# **LOWER ALAMEDA CREEK/BART WEIR FISH PASSAGE ASSESSMENT**

## ***DRAFT ALTERNATIVES EVALUATION REPORT***

*Alameda County Flood Control &  
Water Conservation District*

*August 29, 2006*

**Figure 4-Plan**  
**Proposed Fishway at**  
**B.A.R.T. WEIR and**  
**Middle Inflatable Dam**  
 Alameda County Water District

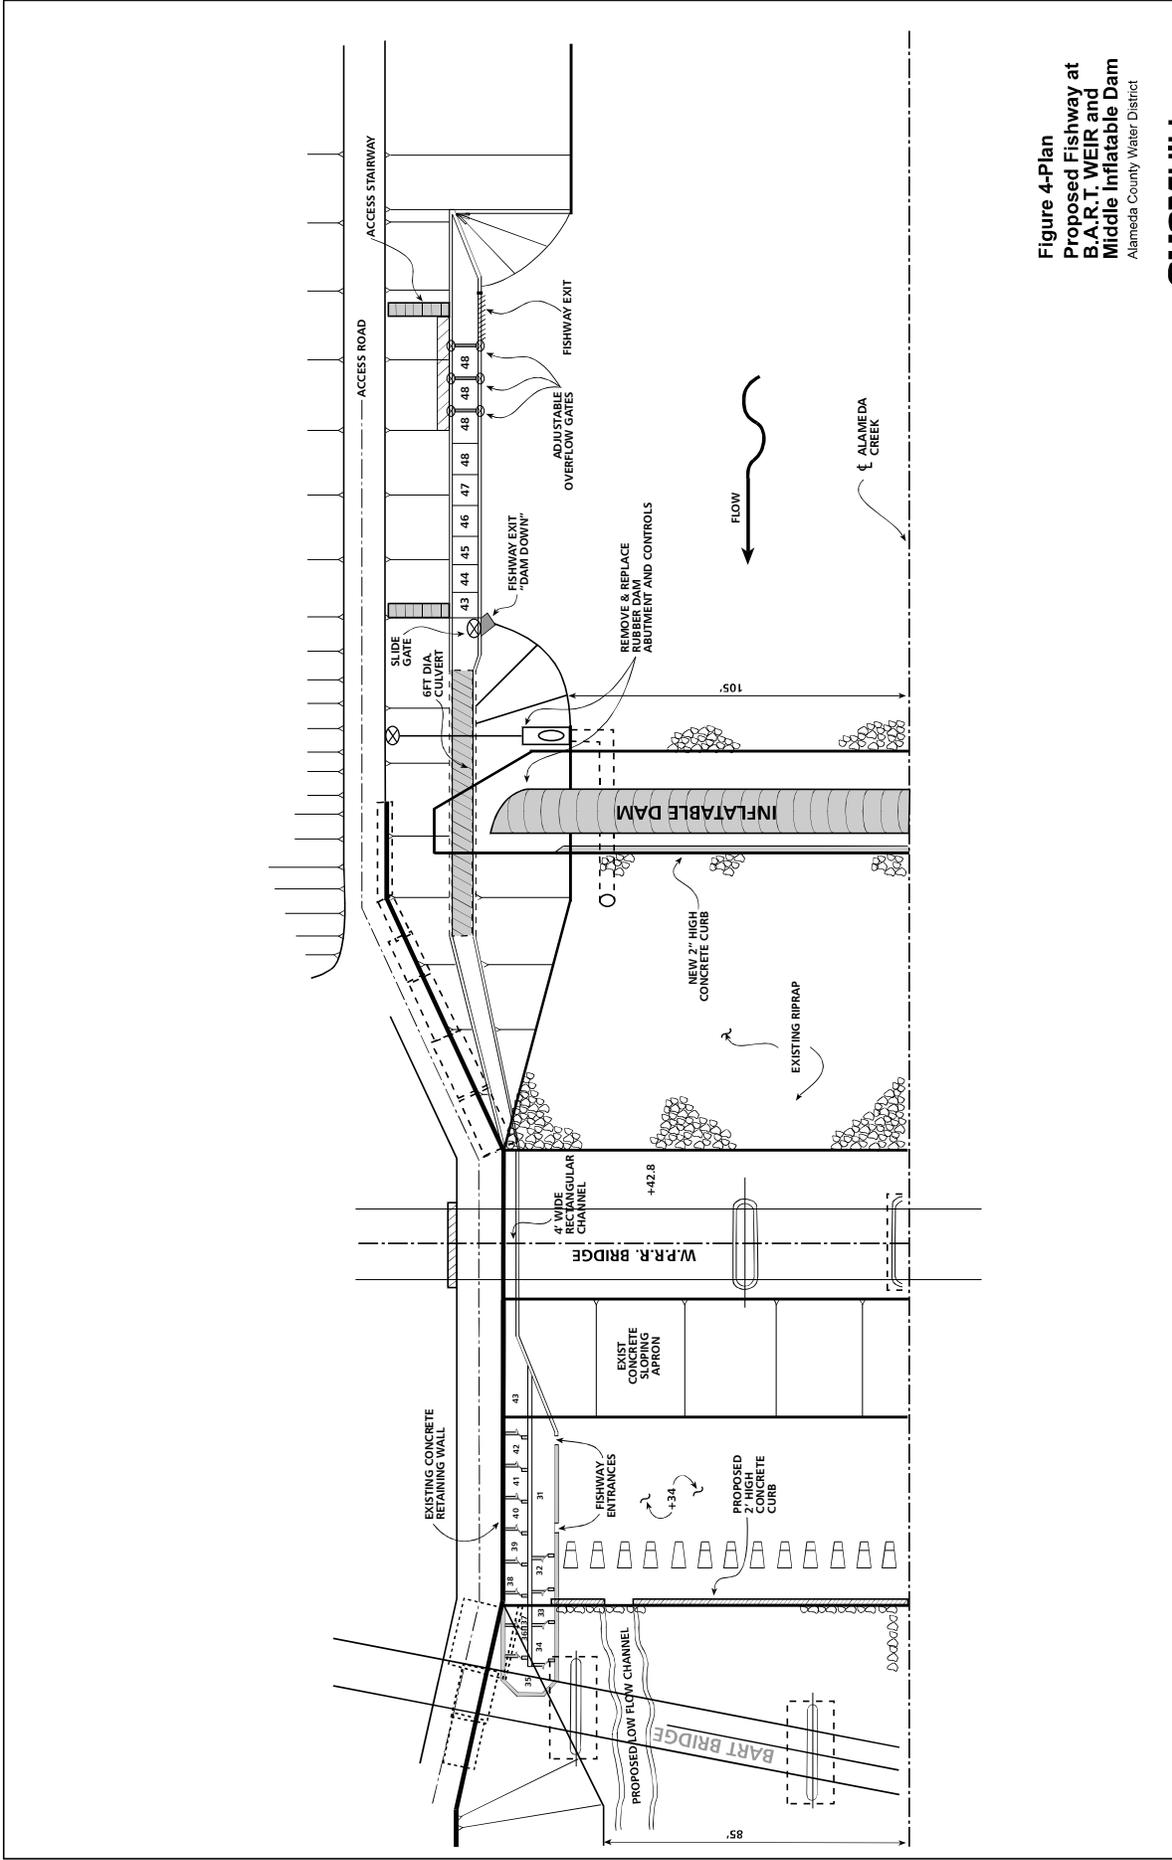
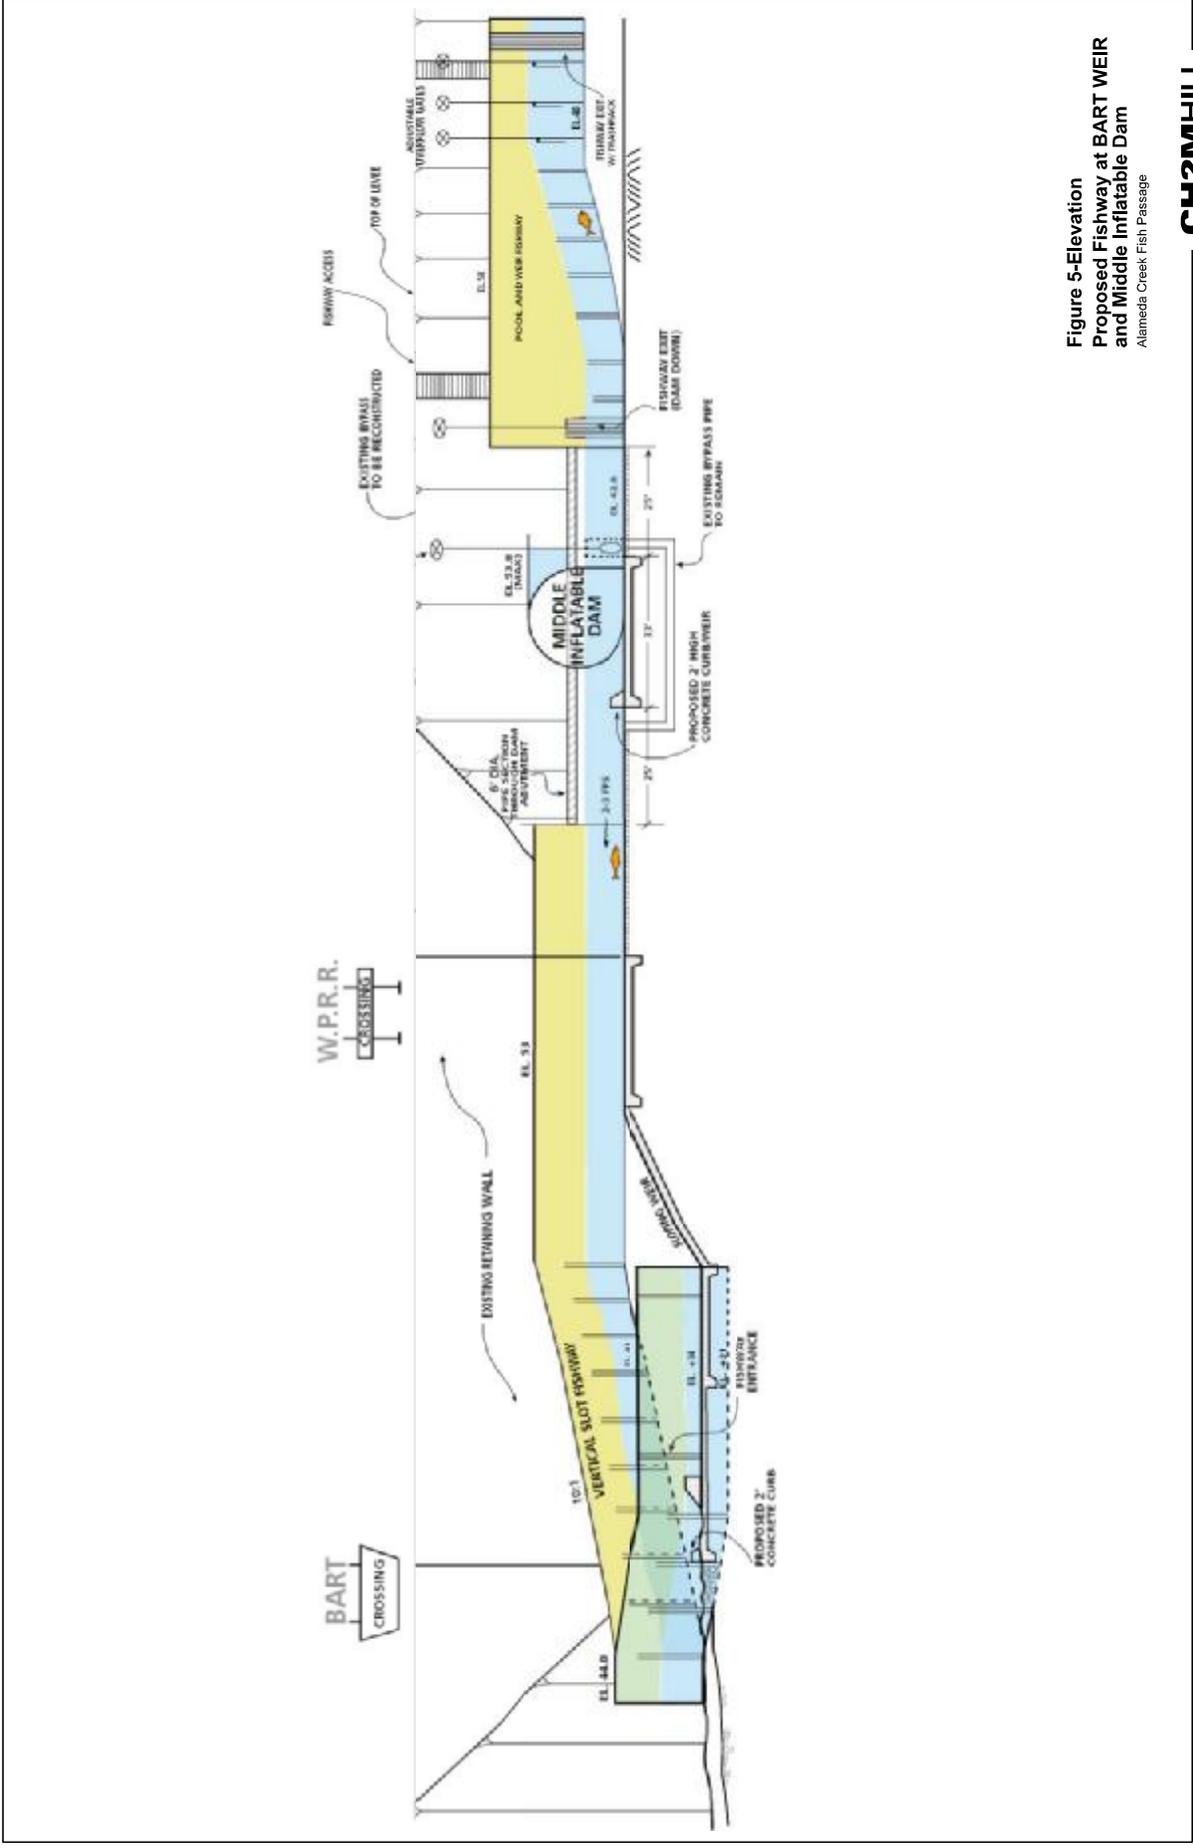
Extended Vertical Slot The design includes a pool-and-weir fishway in the extended segment. There is some risk that steelhead will delay or reject the change in hydraulics within the fishway. We recommend a vertical slot ladder throughout. An extended vertical slot ladder will also eliminate the need for the control gates on the upper three weirs.

Extended Vertical Slot The benefits of this alternative are the same as for the reduced vertical slot fishway. It is recommended the design be modified from the CH2M-Hill report as a continuous vertical slot fishway for its entire length. This will greatly facilitate operations and improve reliability by omitting actuated slide gates.
